Northern Sky Architecture Inc.	Well House	drawn by: kbb	scale: 1:20 date:
100-128 James Avenue Winnipeg, Manitoba, Canada R3B 0N8	La Barriere Park Washroom Replacement	dko	Jan. 16, 2018
contact@nealca Fax 204.968.7979 204.943.6767	4403 Waverley Street, Manitoba	bid opportunity no.: 337-2017	drawing no.: ADD. 1.1

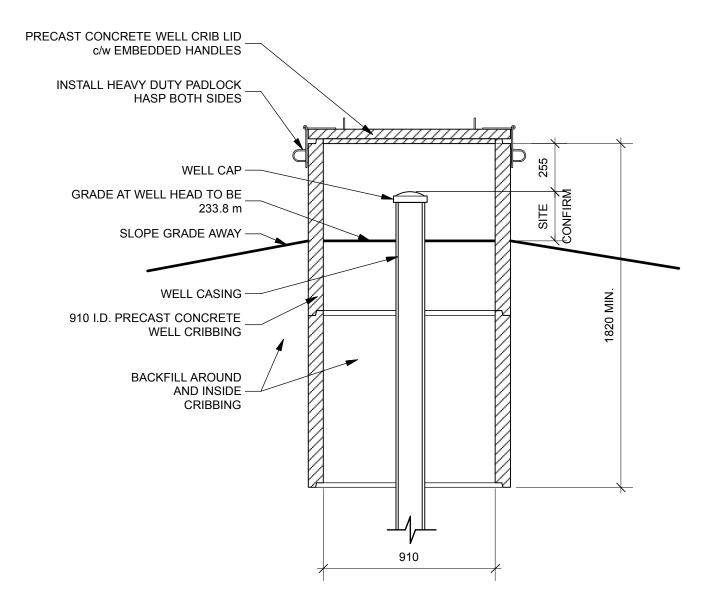
Contractor shall supply and install all work necessary to mechanize existing water well and connect to new washrooms for a fully functioning water supply system. Well is located north and west of the parking lot; Contractor to SITE VERIFY exact location in relation to new washroom prior to tender.

Provide precast concrete well house to protect well head after existing well has been mechanized and connected to the washrooms. Submit shop drawings for review. Please note grade to be built-up around well head to elevation indicated, as per Manitoba Groundwater Management requirements. See Mechanical and Electrical.
